Standard Inventory Item
26 Nosler

6522AD

26 Nosler

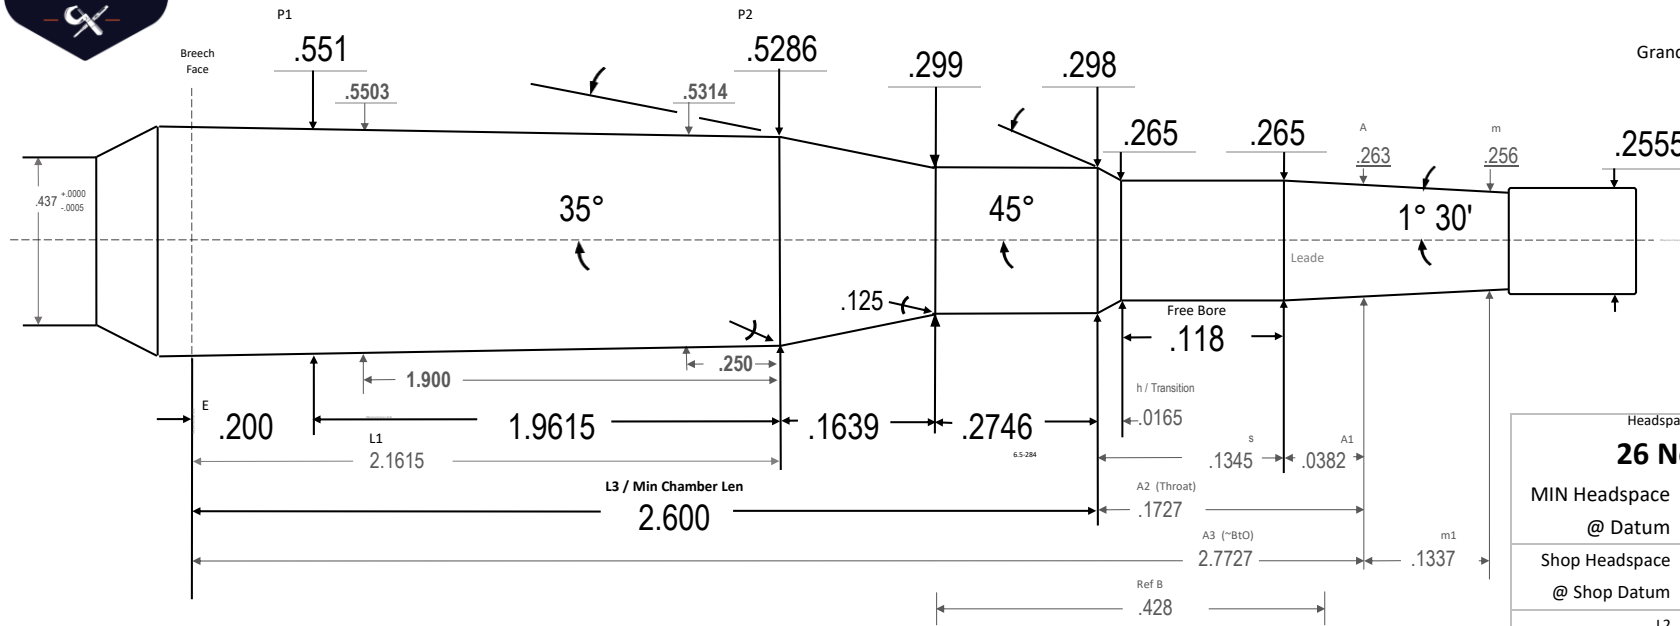
Verified SAAMI 2024 24.04.18rg *note revised lead angle spec of 1° 30'. Previous SAAMI spec (2015) was 3°
